**City of Bellevue
Development Services Department
Land Use Staff Report**

Proposal Name: Karpman Short Plat Amendment

Proposal Description: Application for an Amendment to a Final Short Plat to modify the tree preservation plan shown on the face of the Final Short Plat (King Co. Rec. #20090626900005). Applicant requests the amendment to reassign trees to be retained in order to gain flexibility in placing single family home on the existing western lot – Tract B.

File Number: 16-132531-LF

**Figure 2 – Proposed Amended Short Plat
 3 Trees Retained**

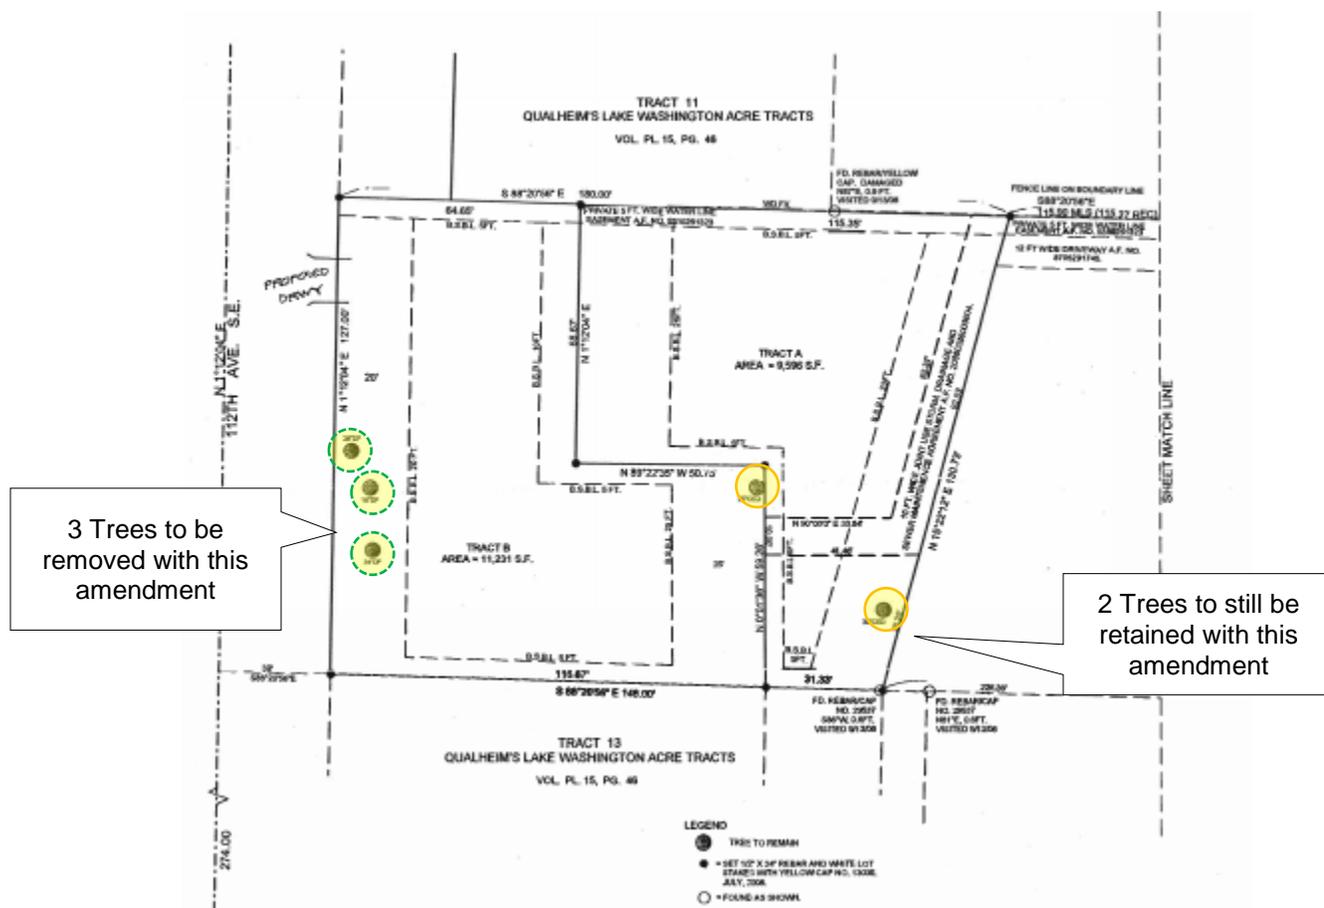
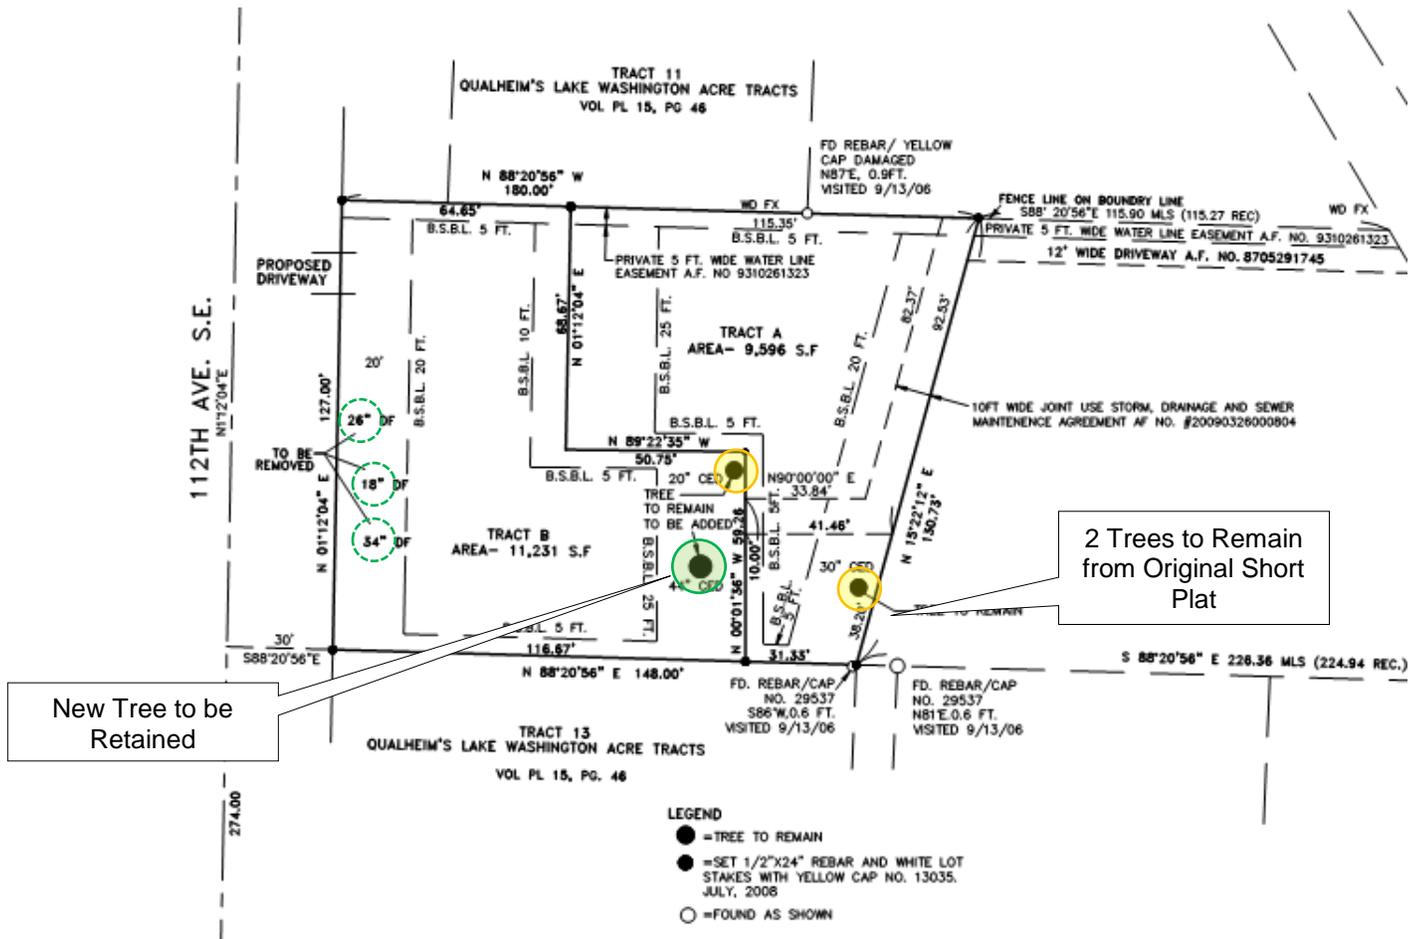
Application for a Final Short Plat Amendment to modify the tree preservation plan shown on the face of the Final Short Plat (King Co. Rec. #20090626900005). The applicant requests the amendment in order to reassign which specific trees are to be retained in order to have more flexibility when designing a single family home on the western Tract B. In the approved Final Short Plat, 15% of the 596 diameter inches of trees on site were required to be retained. Five trees were proposed to be retained for a total of 126 diameter inches or 21%. However, as plans for development of Tract B were explored, three of the trees that were originally proposed to be retained (78 diameter inches total) would be severely impacted by the construction of the foundation of the envisioned home due to their close proximity to both the foundation and the public street. In order to alter the placement of trees to be preserved on the recorded short plat, a short plat amendment application was filed with the City to retain a 44 inch diameter cedar tree along the eastern edge of Tract B in lieu of the three trees along the western edge of the site. With a new total of 94 diameter inches retained, the project would still meet the required 15% tree retention.

1. REMOVE THREE TREES ON TRACT B IDENTIFIED AS 28" DF, 18" DF AND 34" DF.
2. ADD A TREE ON TRACT B IDENTIFIED AS 44" CED.
3. SEE SHEET 2 OF THIS AMENDED SHORT PLAT.

- a) The final short plat shall portray a minimum of 94 diameter inches of existing significant trees to remain. A Tree Preservation Plan that portrays 1) the drip-line measured at 1 foot of radius for each inch of diameter, 2) the diameter size, and 3) common name of each significant tree to be retained must be recorded in the Supplemental Declaration of Karpman Short Plat drawings/mylar. The Tree Preservation Plan must contain the following note with underscoring:
